MECKLENBURG COUNTY
DEPARTMENT OF ENVIRONMENTAL HEALTH

Application for an
Installation, Construction, Alteration, and/or Repair Permit
(Individual Septic Tank System with Subsurface, Soil Absorption, Effluent Discharge)

MECKLENBURG COUNTY
DEPARTMENT OF ENVIRONMENTAL HEALTH
INSTALLATION, CONSTUCTION, ALTERATION, AND/OR REPAIR PERMIT
(Individual Septic Tank System with Subsurface, Soil Absorption, Effluent Discharge)

CERTIFICATE OF APPROVAL

PLOT OF SYSTEM

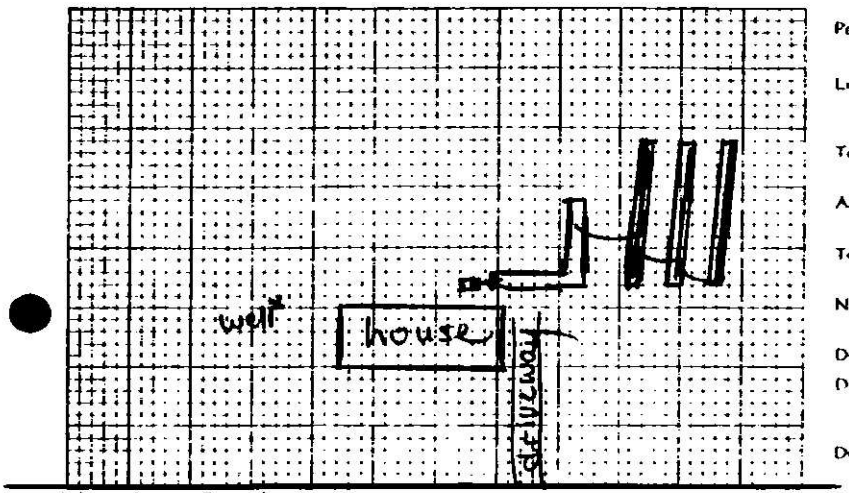
Comments: check to insure that the effluent is reaching the drainfield - add sanitary tee if needed - then, if a repair is needed, overflow to three 67' trenches - 3' wide with 12" of stone
